**REPAIR OF THE AL GHAZALIYAH
G-6 SEWAGE LIFT STATION
UNDER THE COMMANDER'S EMERGENCY RESPONSE PROGRAM
BAGHDAD, IRAQ**

**SIGIR PA-07-118.1
APRIL 22, 2008**

SUBJECT: Report on Project Assessment of the Repair of the Al Ghazaliyah G-6
Sewage Lift Station, Baghdad, Iraq (Report Number SIGIR PA-07-118.1)

Site Photo 5. Manhole outside the G-6 building (Photo courtesy of the USACE)

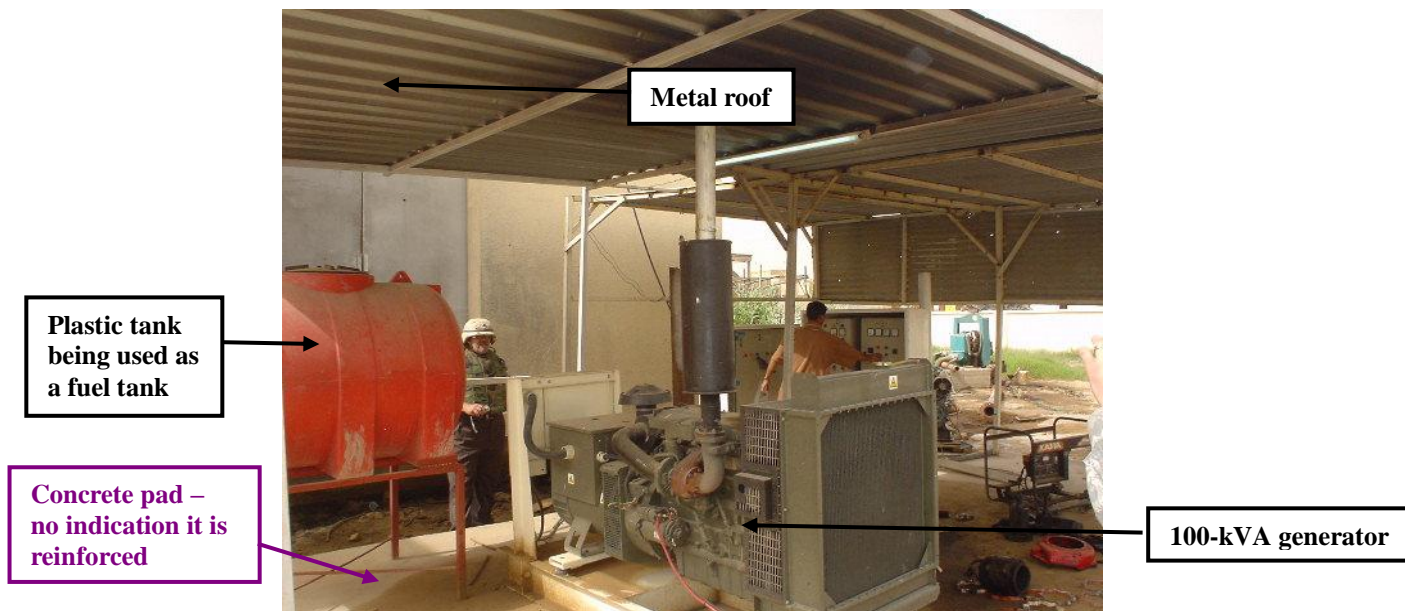
The SOW, when compared to the contractor’s “Engineering Report”, indicates the two submersible pumps will be installed inside the G-6 building. Specifically, the two submersible pumps were to match the existing pumps. However, according to a site visit conducted by the USACE in April 2007, the submersible pumps are located outside the G-6 building (Site Photo 5). A site report was written and stated that “one of the submersible pumps still is not connected electronically to the generator or to the national power, piping connection not completed yet.” The two pumps visible in Site Photo 5 appear to be above-ground diesel pumps, not submersible pumps.

The contract file lacked documentation to explain the need for the above-ground diesel pumps and/or submersible pumps outside the lift station facility. Given the absence of contract file documentation and the SIGIR inspection team’s inability to visit the site because of the security situation, available contract file photographs indicate the pumps were used outside. It is possible they were used to bypass the G-6 facility and pump the sewer water from the manhole in front of the facility to the next one along the line. This would provide short term relief of incoming sewer water to the G-6 facility while the contractor renovated and upgrades the facility. As previously mentioned in the Project Design and Specifications section, the contractor did not provide design drawings to identify the use of the equipment required by the SOW. However, it appeared the original intent was to use the two submersible pumps either to replace or compliment the two existing submersible pumps inside the facility.

Further, based solely upon available contract file documentation, we cannot determine if the submersible pumps were ever delivered or installed. For example, none of the daily QA reports mention the delivery or installation of the submersible pumps; while the daily QC reports are contradictory regarding the delivery and installation of the pumps. For instance, on 14 December 2006 and 16 December 2006, the contractor’s QC daily reports each stated “installing the pump;” while the 17 December 2006 daily QC report stated

“installed the two pumps.” However, this is contradicted by five subsequent daily QC reports, each stating “supplying the pumps.” None of the three daily QC reports provided photographs of the contractor installing the pumps. The contract file lacked any photographs or narratives to verify the delivery and installation of the two 150-mm submersible pumps.
